Number F.1.
Section Gearbox and
Overdrive
Sheet 1 (of 1)
Date October, 1961

GEARBOX CONSTANT PINION OIL SEAL

Number F. 2
Section Gearbox and
Overdrive
Sheet 1 (of 1)
Date April, 1962

Number F.13.
Section Gearbox and Overdrive.

STICKING IN 1ST GEAR.~~(All synchromesh gearbox models)~~

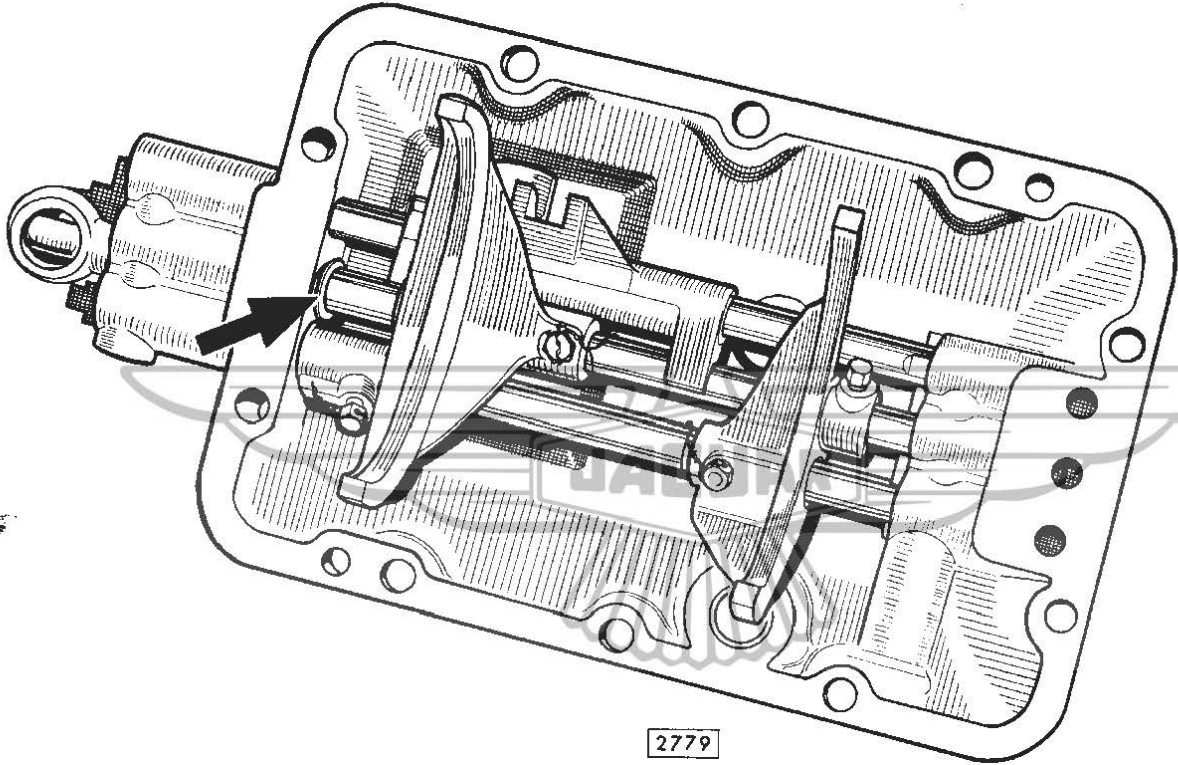
If difficulty is experienced with sticking in first gear the following procedure should be adopted.

Remove the console trim and gearbox tunnel cover, then the top cover of the gearbox. It may then be necessary to use two levers to ease the 1st speed gear forward on the 2nd speed synchro-sleeve. Ignore the slight damage which may have occurred to the stop pin on the 2nd speed synchro-sleeve.

With the gearbox top cover on the bench, remove the selector housing by taking off the four retaining nuts. This will expose the three plunger springs which should be removed together with the plunger and balls (and shims if any). Withdraw the centre welch washer at each end of the top cover by piercing and prising as necessary. Then remove the wired dowel pins retaining the stop and the change speed fork on the centre striking rod so that this may be driven forward a sufficient amount to fit a washer $\frac{3}{4}$ " (19 mm) outside diameter and $\frac{1}{2}$ " (12.7 mm) inner diameter, thickness $\frac{1}{16}$ " (1.6 mm) onto the rod behind the change speed fork. Ensure that the washer clears the selectors on the other striking rods. (See illustration overleaf).

Replace the striking rod, change speed fork and stop and refit the two dowel pins wiring them up as before. Fit new welch washers either end of the top cover then replace the three balls, plungers, springs and shims (if fitted) in the respective holes. Use a new gasket when replacing the selector housing and fit a new gasket on the gearbox case top face. Place the gearbox in neutral offer up the top cover noting that it is located by two dowels and secure in position with the ten setscrews and spring washers (two long screws at rear and two short screws at front). Replace the tunnel cover and trim.
